APPLICATION NO.	FILING DATE	FIRST NAMED INVENTOR	ATTORNEY DOCKET NO.	CONFIRMATION NO.
10/067,218	02/07/2002	Dan A. Steinberg		6453

Office Action Summary

DETAILED ACTION

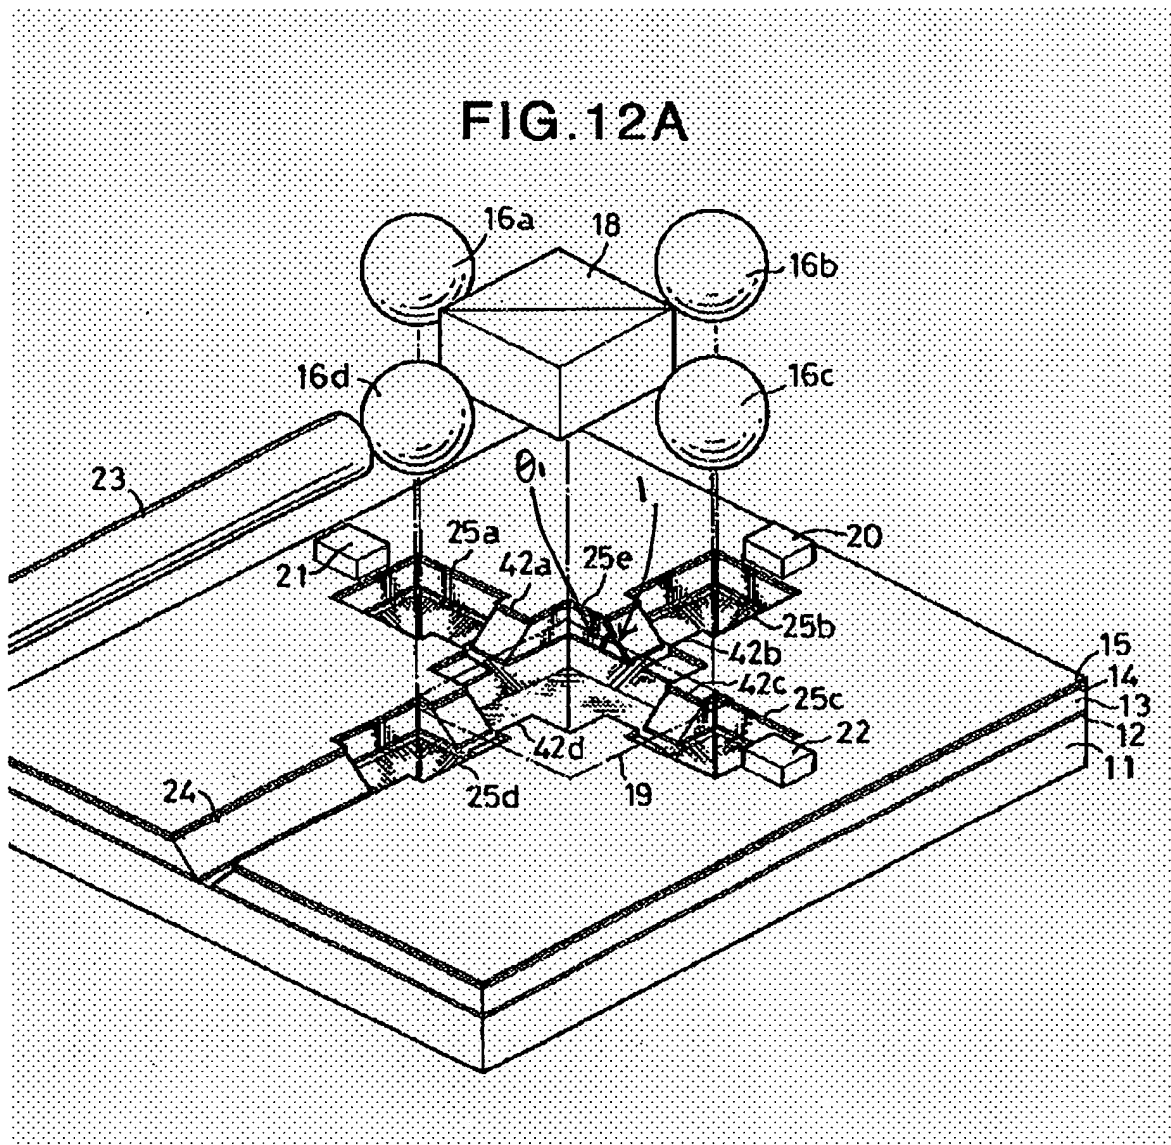
Examiner does not agree with Applicant's argument because Tabuchi clearly shows the sidewall that intersects a respective side of the pit at a non-orthogonal angle relative to a longitudinal axis of the respective groove section. See the arrow 1 in the pasted drawing of Fig. 12A. The line of arrow 1 is formed by the sidewall of the groove and the sidewall of the pit. The line of arrow 1 is clearly non-orthogonal to the longitudinal axis of the groove section, and the angle $\theta_1 < 90^\circ$ is formed by the line of arrow 1 and the longitudinal axis of the groove section.

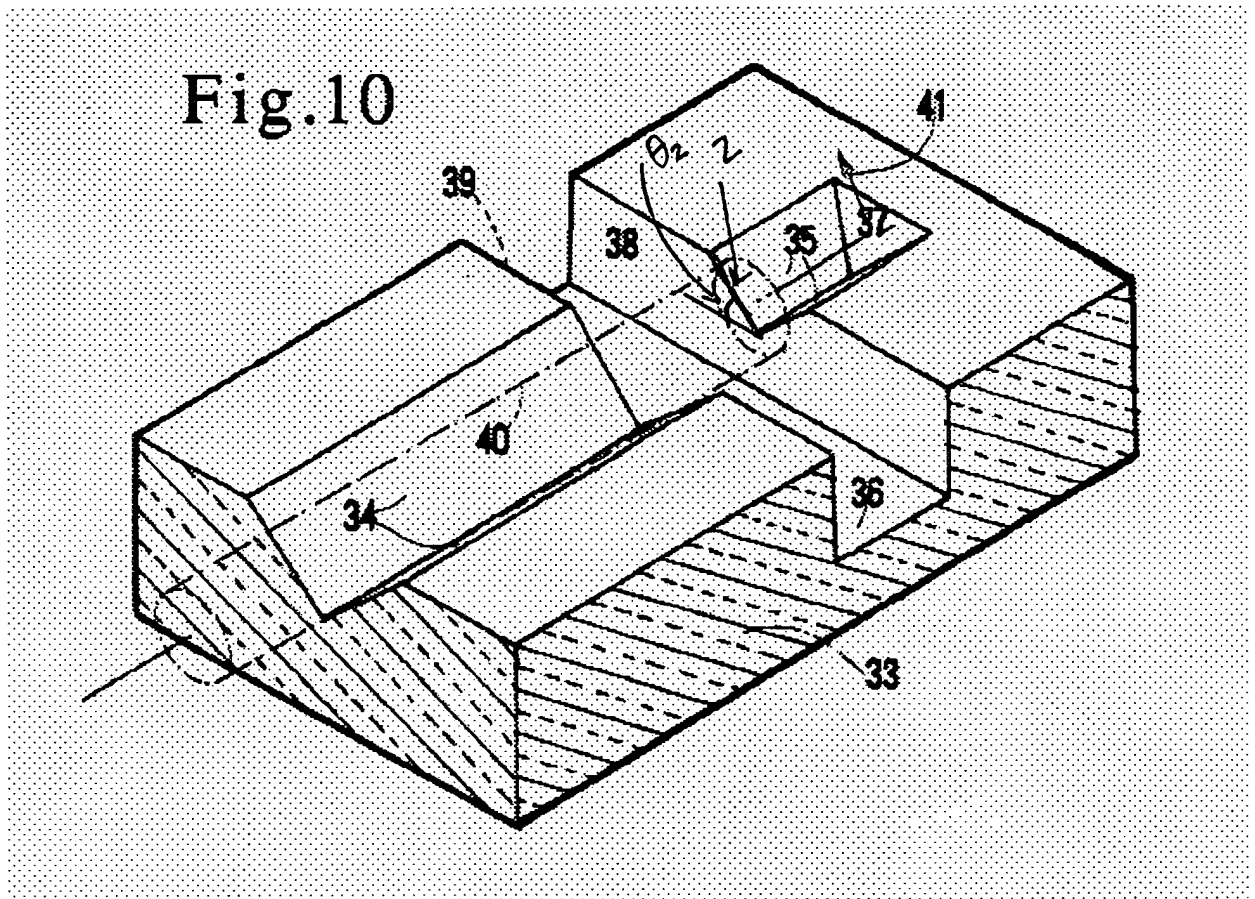
Applicant further argues that Nakanishi does not disclose or suggest the non-orthogonal angle. See the line of arrow 2 in the pasted drawing of Fig. 10 below. The line of arrow 2 is formed by the sidewall of the groove 35 and the sidewall of the pit 36. Again the angle $\theta_2 < 90^\circ$ is formed by the line of arrow 2 and the longitudinal axis of the groove.
